**DEMAND FOR A MORE REALISTIC
RATE OF CHANGE OF FREQUENCY (RoCoF) VALUE
BASED ON RECENT SYSTEM SPLITS
ON 8 JANUARY & 24 JULY**

GC ESC 22 SEPTEMBER 2021

Frequency data on 8/1/2021 (according to www.gridradar.net)

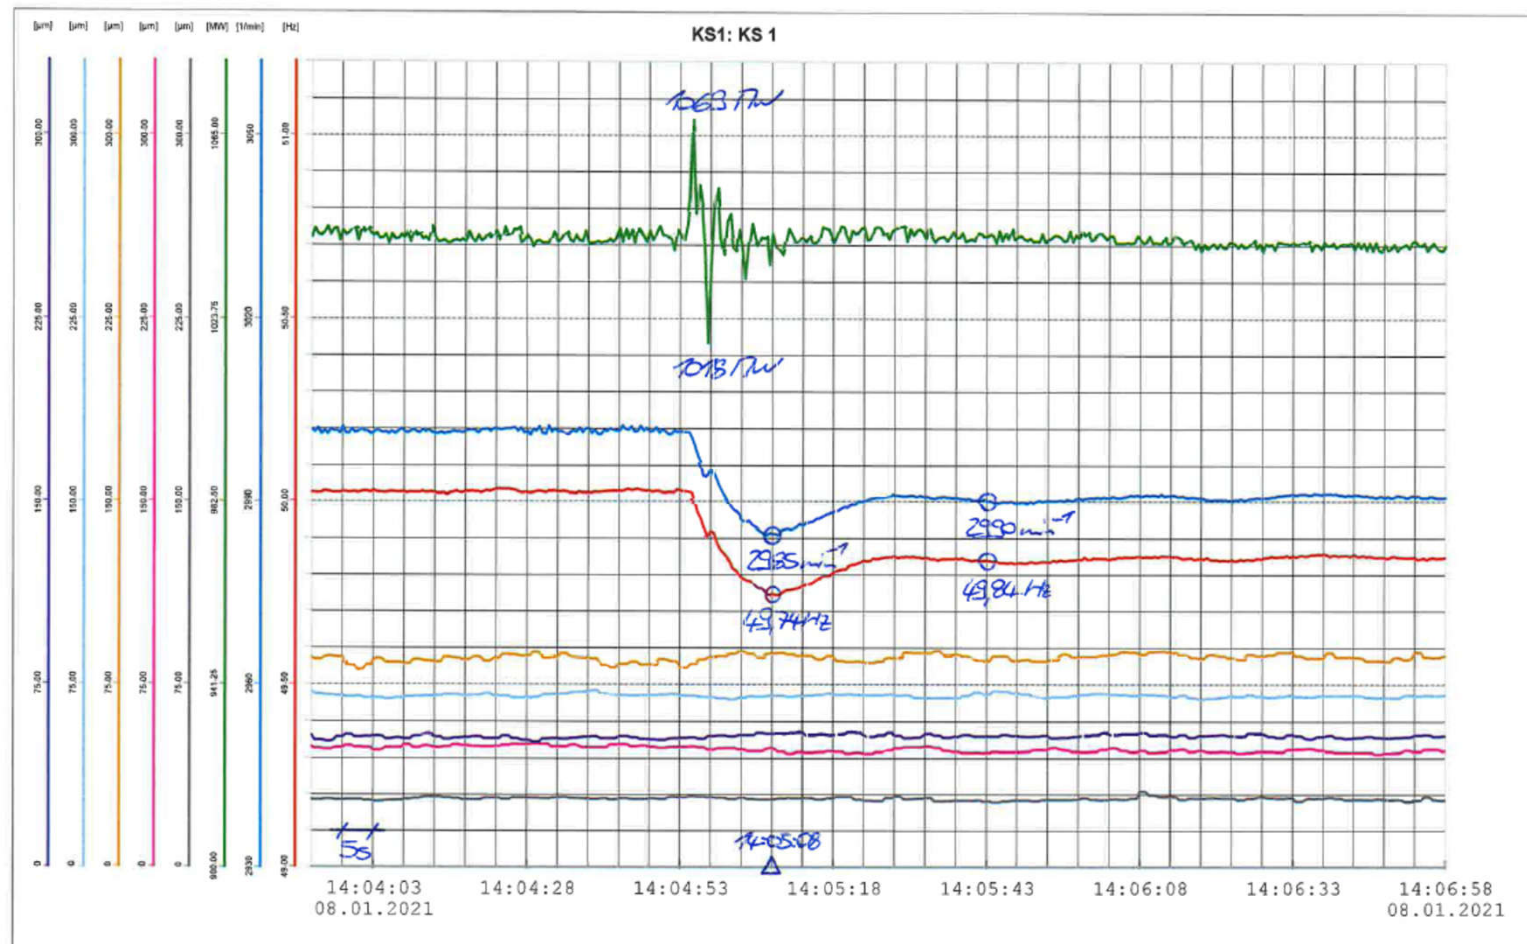
Average RoCoF during 13 sec : 20 mHz/sec

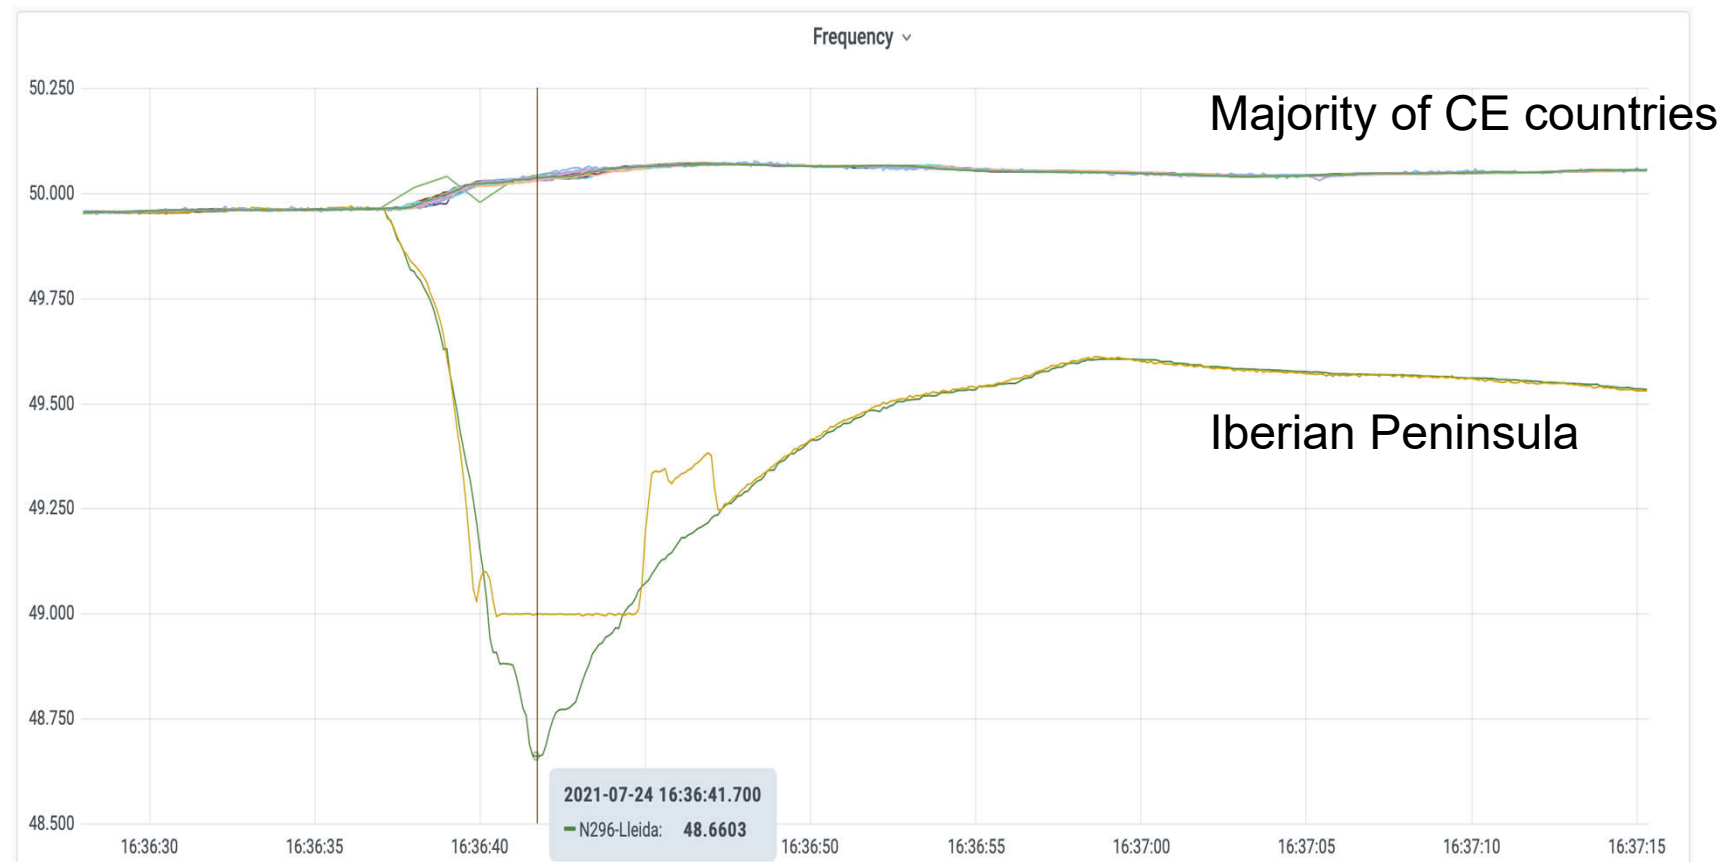
A detailed analysis of the RoCoF is missing in the report.

More information is needed about:

- Technical details about the registrations of the frequency made by TSOs
- Specifications of the TSO's measurement equipment or processes to define the RoCoF including the size of the measuring window because 3 sizes of the measuring window considered in the requirements of Member States: 0,5 sec / 1 sec / 2 sec (see FGH study slide).
- Any intention from ACER or ENTSOE to harmonise the measuring window. The FGH study mentions values of 0.5 sec, 1 sec and 2 sec.
